Reviewers' comments:

Crystalline TiO2 protective layer with graded oxygen defects for efficient and stable Si-based photocathode
The manuscript titled "Crystalline TiO2 …... Si-based photocathode" deals with the black-Si photocathode for PEC water-splitting and black-TiO2 surface protection. The resultant photocathode shows excellent stability under harsh pH conditions. The authors have addressed two major revisions with more characterizations and measurements. Overall the manuscript has improved a lot and other than some inherent characteristics of p-Si without p-n junction. Overall, I would recommend the manuscript for publication in prestigious Nature communication with below modifications.

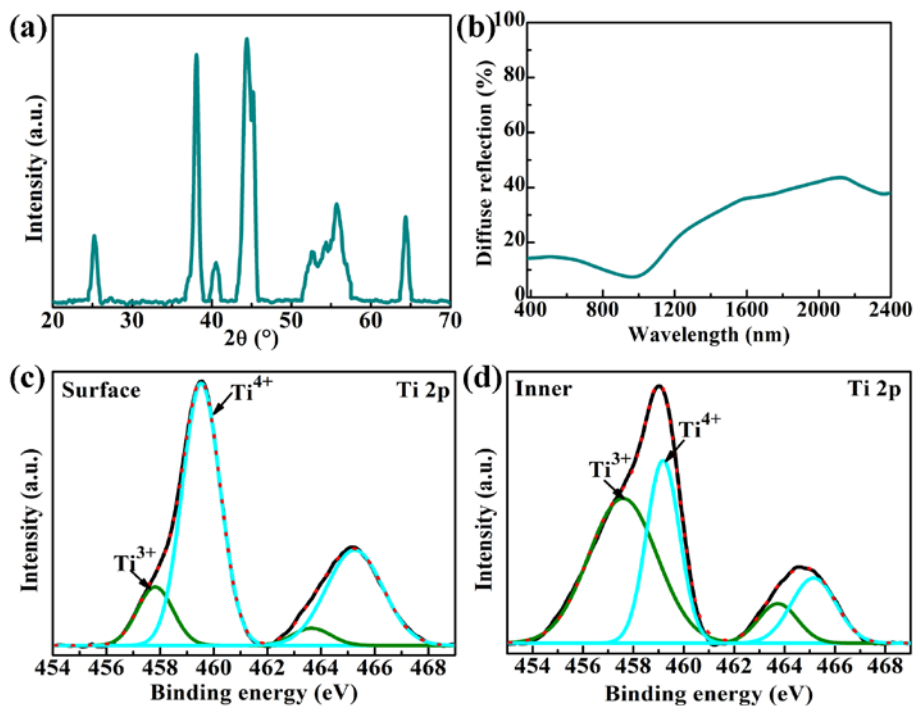
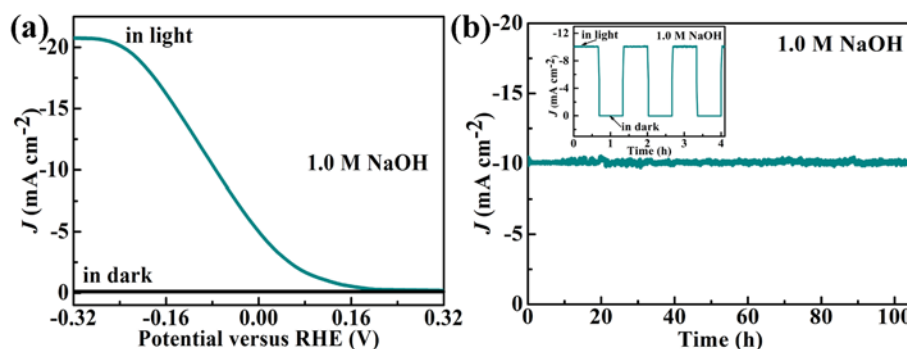
Q1) The main achievement of the manuscript is a promising stability/durability of the protection layer, however, the characterization, analysis and evaluation is to some extend made more difficult and obscured by the choice of black silicon (b-Si) as photo-absorber due the surface roughness. The case for the protection layer could probably have been more clearly made with a planar silicon photo-absorber, where corrosion or stability could be convincingly demonstrated for a Pd/b2-TiO$_2$/Si sample. Then b-Si samples could have been added if they contributed to the case.

Based on your suggestion, the characterization and PEC performance of Pd nanoparticles/black TiO$_2$/planar Si (Pd/b2-TiO$_2$/planar Si) have been analyzed and measured to further confirm the characterization and effect of the protection layer. As shown in the revised manuscript, the black TiO$_2$ layer showed graded oxygen defects. Even though Pd/b2-TiO$_2$/planar Si photocathode had a lower limiting current than Pd/b2-TiO$_2$/b-Si photocathode, the black TiO$_2$ layer still provided a promising stability in 1.0 M NaOH. Thus, the Si with or without nanostructure hardly affects the characterization, analysis and evaluation of the protection layer.

{Characterization and photoelectrochemical profile of cocatalyst/protective layer/b-Si: "…… In addition, the characterization, analysis and PEC measurements of Pd/b-TiO$_2$/planar Si (substituting planar Si wafer to black Si wafer) further demonstrate the effect of b-TiO$_2$ protection layer roundly (Supplementary Figs. 26-28). ……"

Figure 33. (a) Schematic of a four-point measurement with line-up tips forming the contacts on the surface of the planar Si. (b) Equidistant four-probe current-voltage curves of the planar Si.

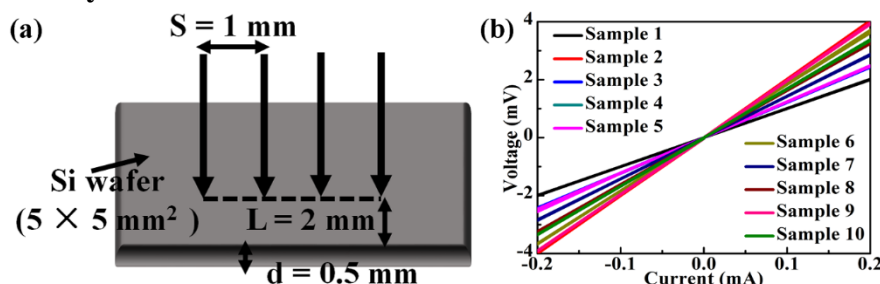
Q3) A minor detail regarding the reply to my question #1 about the silicon resistivity: Even though you do not supply details about how the four-point measurement was done, I suspect that the calculated resistivity is off by a factor of approximately 5 (i.e., exactly π/ln2) off; please consult literature on four-point measurements.

Firstly, we used a wrong equation to calculate the silicon (Si) resistivity in the previous response. According to your recommendation, we carefully consult the literatures on four-point measurements and recalculate the Si resistivity as follows.

As shown in Supplementary Fig. 33a, the thickness of Si wafer (d), the tip-tip distance (S) and the distance between tip and sample edge (L) are 0.5, 1 and 2 mm, respectively. The resistivity (ρ) of Si wafer is calculated as follows:

$$\rho = \frac{2\pi S}{B_0} \cdot \frac{V}{I}$$

where I is the applied current, V the corresponding voltage, S the tip-tip distance and B_0 the correction factor (3.104) determined by S/d and L/S. Based on the resistance (R) ranged from 10 to 20 Ω, the real resistivity of Si is around 2-4 Ω·cm.

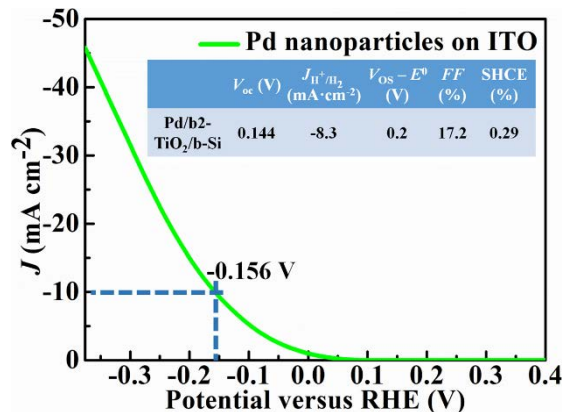
Q1) As the MS deals only with photocathode the half-cell efficiencies (Solar to hydrogen conversion efficiencies (SHCE)) should be shown. (Not as in Figure S22). For more details pl. refer recent article in Nature Energy, 3, 185-192 (2018), Nano Lett. 15, 2817-2824 and other papers cited therein.

According to the methods reported by the articles, the solar-to-hydrogen conversion efficiencies (SHCE) has been provided in the updated manuscript as below:

{Characterization and photoelectrochemical profile of cocatalyst/protective layer/b-Si: "…… But regrettably, the solar-to-hydrogen (STH) efficiency and solar-to-hydrogen conversion efficiency (SHCE) of Pd/b2-TiO$_2$/b-Si (Supplementary Figs. 21 and 22) were low because of the lack of p-n junctions. ……"

The preparation conditions of Pd nanoparticles on ITO are identical to those in b2-TiO$_2$/b-Si. The V_{OC} is calculated as follows:

$$SHCE = \frac{\left|V_{OS} - E^0\right| J_{H^+/H_2} FF}{P_{incident}}$$
